## GFA AIRWORTHINESS DIRECTIVE

**SUBJECT:** Cracks in the aileron steel pipe spar around the welded hinge bushings.

<b>GFA AD 519</b>	<b>ISSUE: 1</b>	<b>21. October 1999</b>	<b>Page 2 of 4</b>
-------------------	-----------------	-------------------------	--------------------

SCHEIBE- Flugzeugbau GmbH August- Pfaltz- Str. 23 85221 Dachau LBA-approval I-B 3/I-EB2	<b>Service Bulletin 653- 73</b>	<b>SF 25 B / C</b> <b>TCDS.: 653</b> Page 1 of 2
--	---------------------------------	--

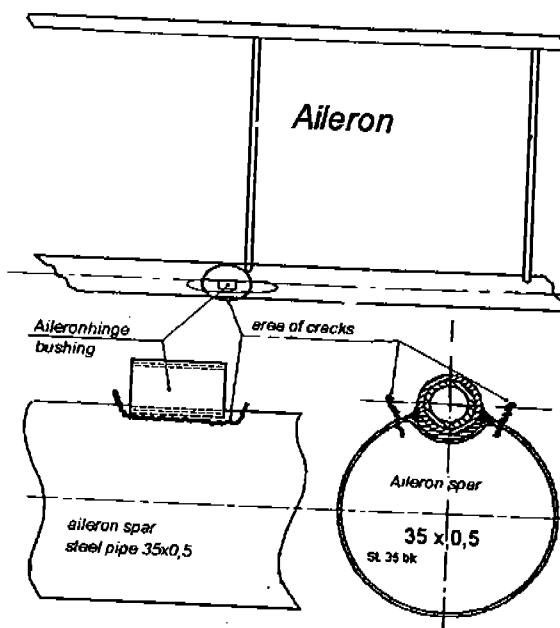
**Reason:** During inspection of a motorglider one aileron hinge was found to be broken out of the aileron steel pipe spar. On one aileron hinge bushing of another motorglider cracks have been detected around the hinge bushing weld seam (see following sketch)

Reinforcement sheet joint

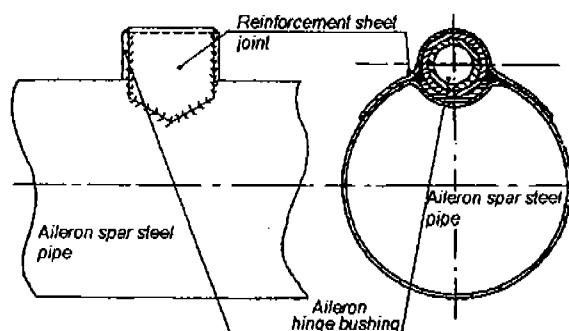
2. If cracks are found aileron hinge bushings must be reinforced in accordance with the following sketch.
- If cracks are detected around an aileron hinge bushing or if a hinge bushing is worn out, corrosion inspection of the inside of the aileron spar steel pipe is requested, because moisture may have appeared in period of time.

- If corrosion is detected inside the aileron spar steel pipe please contact SCHEIBE Flugzeugbau GmbH for special repair instructions.
- If one aileron hinge bushing must be reinforced all three hinge bushings on both ailerons of the motorglider must be reinforced. After reinforcing of the hinge bushings by a steel sheet joint (see the following sketch) special inspections according to point 6a of the manufacturer's maintenance checklist last edition will no longer be necessary.

**Remarks:** Take care for a correct alignment of the welded in aileron hinge bushings with the wingside hinge bolts.
